Alternative Technical Concept #5

Use of PVC Piping on Standpipe System

IH 635 MANAGED LANES PROJECT – CONFIDENTIAL ATCs

ALTERNATIVE TECHNICAL CONCEPT - NUMBER 5 (ATC-05)

IH 635 MANAGED LANES PROJECT **ATC 05 Exhibit – PVC for Buried Standpipe**

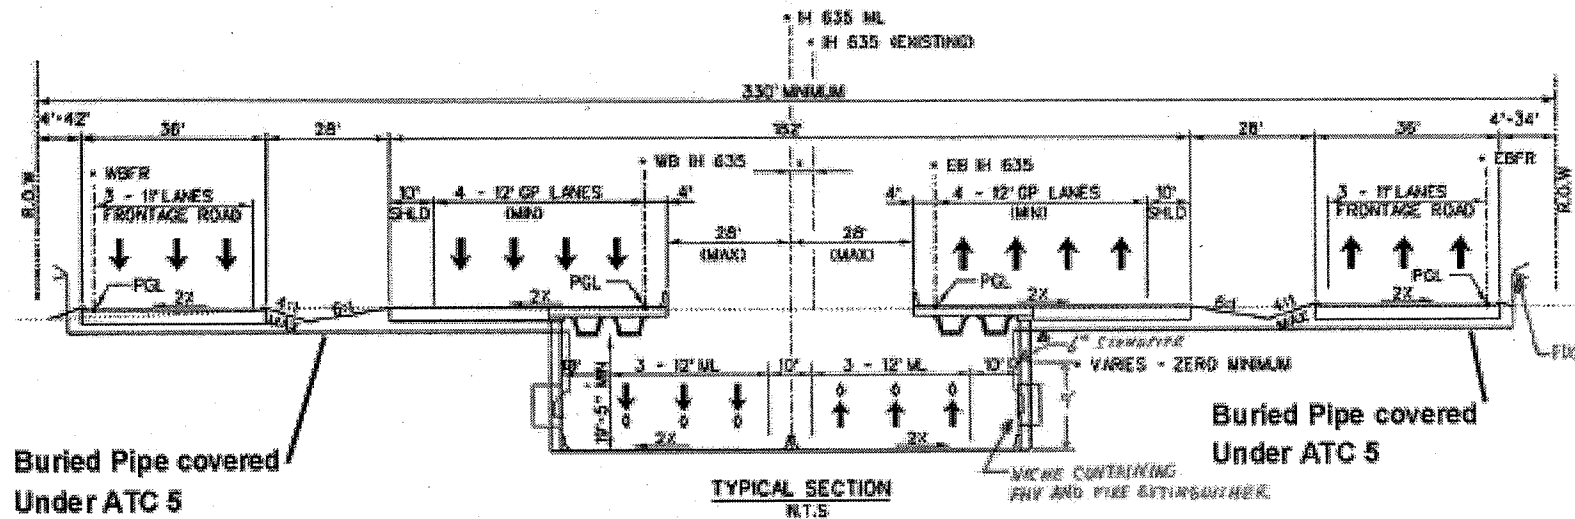
Attached is a typical section depicting the standpipe system; the dry standpipe system requirements are specified by TxDOT under Book 2A section 25.2.3.3. This ATC is intended to obtain a deviation from the Fire Protection requirements of the book 2A section 25.2.3.3 c) that defines the material to be used for the fabrication of the standpipe **system**. The proposer's intention is to use PVC for the standpipe system instead of the required Galvanized Steel for buried pipe application. Exposed piping will be Galvanized Steel. Attached is a drawing depicting what the proposer understands to be the standpipe system. With approval of this ATC, the following revision would be made to the third bulleted paragraph under Book 2A, Section 25.2.3.3 c) after Conditional Award, but prior to execution of the CDA:

The location where this ATC will be applied is on buried portions of the standpipe system for the depressed Managed Lanes of IH 635 and piping from Dallas Water Utilities (DWU) mains to new fire hydrants as appropriate.

This ATC is justified because the difference in cost of construction between the PVC pipe, and the Galvanized pipe is very significant (Saving number on question s). The standpipe system with PVC piping will fully comply with all the other requirements of chapter 25 of the Technical book 2A. The proposer will comply with the handback requirements of book 1 section 8.10, and book 2A section 19.6. Following codes allow use of PVC pipe according to AWWA C900. AWWA Class 200 is normally used for fire protection piping.

In accordance with Item (j) of the Proposer's ATC, TxDOT acknowledges the Proposer's request for a deviation from the Book 2A Section 25.2.3.3.c) requirement that specifies galvanized steel pipe for the standpipe fire protection system. However, TxDOT will not specify in the conformed documents that "Buried portions of the standpipe system may be fabricated from either galvanized steel or polyvinyl chloride (PVC) pressure pipe." The following language would be acceptable to TxDOT for the ATC in modification of the requirements in Section 25.2.3.3.c) third bullet:

- FDCs for each standpipe shall be installed remote from each other, preferably at both ends of the standpipe such that the standpipe can be filled from either of the two locations. Standpipes shall be a minimum of 4-inches in diameter.

IH 635 MANAGED LANES PROJECT **ATC 05 Exhibit – PVC for Buried Standpipe**

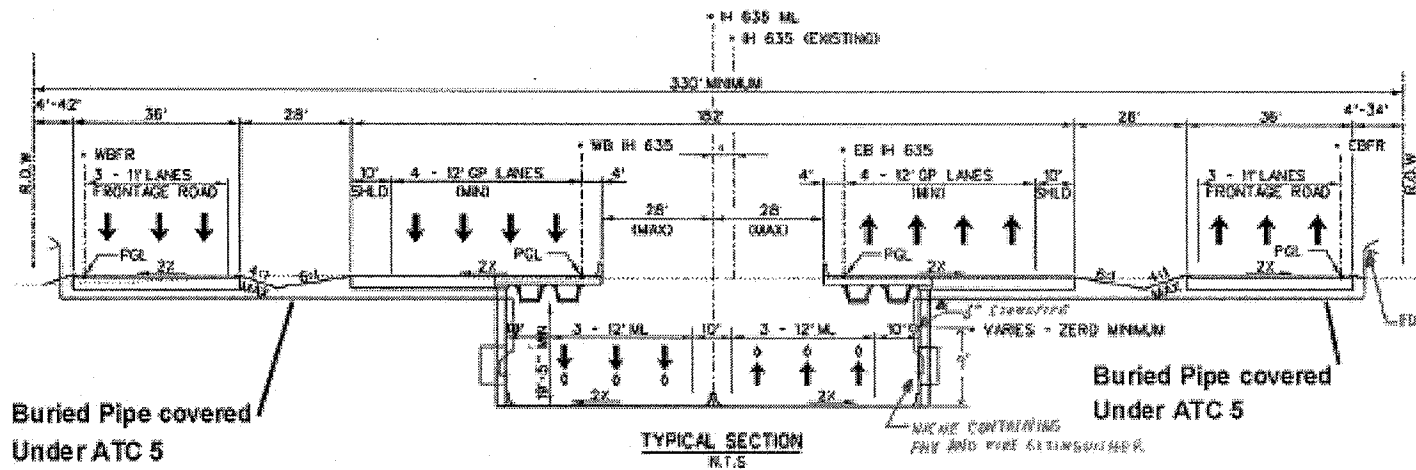
Attached is a typical section depicting the standpipe system; the dry standpipe system requirements are specified by TxDOT under Book 2A section 25.2.3.3. This ATC is intended to obtain a deviation from the Fire Protection requirements of the book 2A section 25.2.3.3 c) that defines the material to be used for the fabrication of the standpipe **system**. The proposer's intention is to use PVC for the standpipe system instead of the required Galvanized Steel for buried pipe application. Exposed piping will be Galvanized Steel. Attached is a drawing depicting what the proposer understands to be the standpipe system. With approval of this ATC, the following revision would be made to the third bulleted paragraph under Book 2A, Section 25.2.3.3 c) after Conditional Award, but prior to execution of the CDA:

- "FDCs for each standpipe shall be installed remote from each other; preferably at both ends of the standpipe such that the standpipe can be filled from either of the two locations. Standpipes shall be a minimum of 4-inches in diameter ~~and be fabricated from galvanized steel.~~"

The location where this ATC will be applied is on buried portions of the standpipe system for the depressed Managed Lanes of IH 635 and piping from Dallas Water Utilities (DWU) mains to new fire hydrants as appropriate.

ATC #5 - CINTRA_ATC-05_USE OF PVC PIPING ON STANDPIPE SYSTEM. ATC # 5 is acceptable for inclusion into the proposal with the further clarification that 25.2.3.3.c will be amended in the conformed CDA Documents to read:

- FDCs for each standpipe shall be installed remote from each other; preferably at both ends of the standpipe such that the standpipe can be filled from either of the two locations. Standpipes shall be a minimum of 4-inches in diameter.
